Access Compliance Report

Public Rights-of-Way

(Pedestrian Signals)

Intersection ID: N/A	Main Street:	Cross Street: N/A	Location: N/A
ADA ID: AB52C280B492	Signal Type: One Push Button-Non APS	Overall Compliance: No	Severity Score: BTN 1: N/A BTN 2: N/A No BTN: N/A
Codes/Mitigation Info/Possible Solution		Field Measurements/Component Compliance

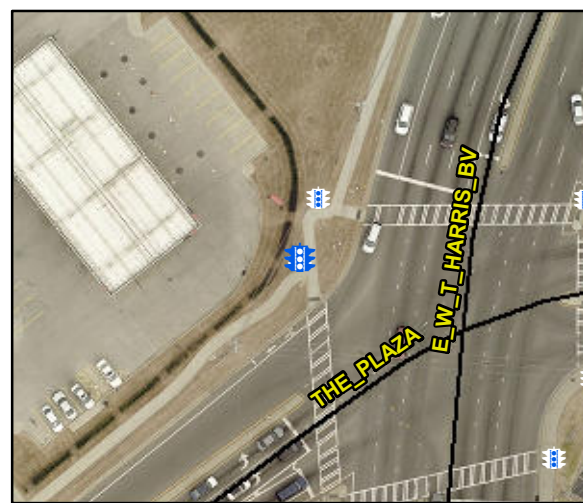
Surveyor Notes: TEXT HT 1/2

PROW/ADA: R410.6, TMUTCD 4e.08, R406.2, R404.7.3

Possible Solutions: Replace Signal Push Button With APS Button on New Post. Remove & Replace Sign.
